Subject: FW: 2016/2424/P

From: McCarthy, Mark [REDACTED]
Sent: 14 August 2016 21:31
To: Hazelton, Laura
Subject: Re: 2016/2424/P

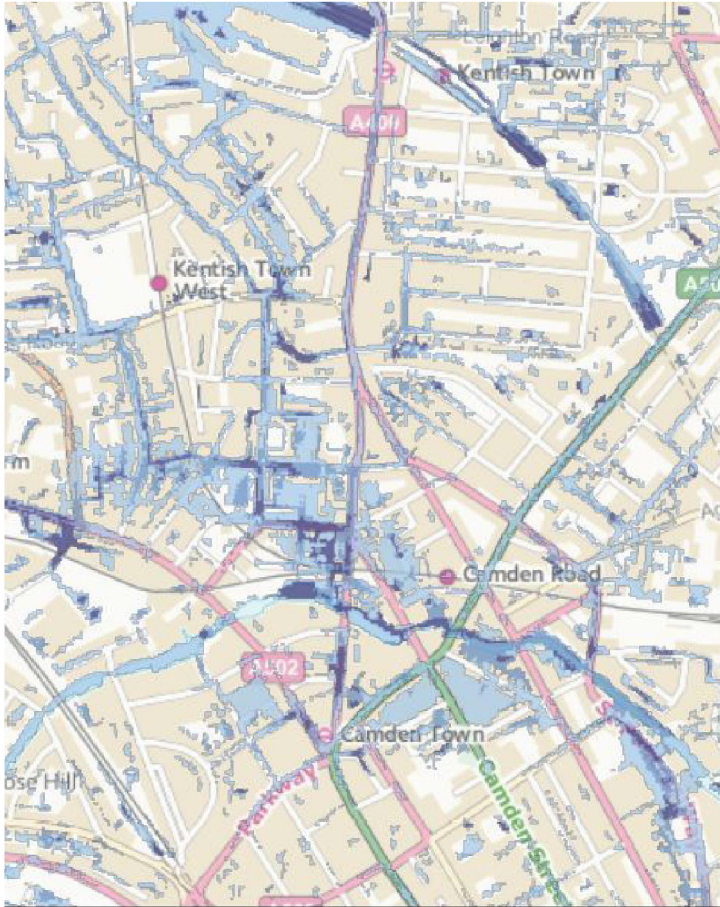
Also, for the BIA. It's a standard report, but fails to be fully aware of the local position. This is the former bed of the Fleet, and - while Rochester CA has an image of a plan showing (in the 1810s) a duct/sewer running from 1 Farrier Street across KTR to Camden Street - the topography makes this the natural drainage point for subsurface water. Moreover, the Highgate and Hampstead branches of the Fleet met at Hawley Road, and regularly flooded on the east side (which is why Camden Gardens is not built on). There have been boreholes recently nearby (Kentish Town Road, Rochester Place) which have shown the springline, since the boreholes fill with water. This is also shown by the EA's surface water flood map:
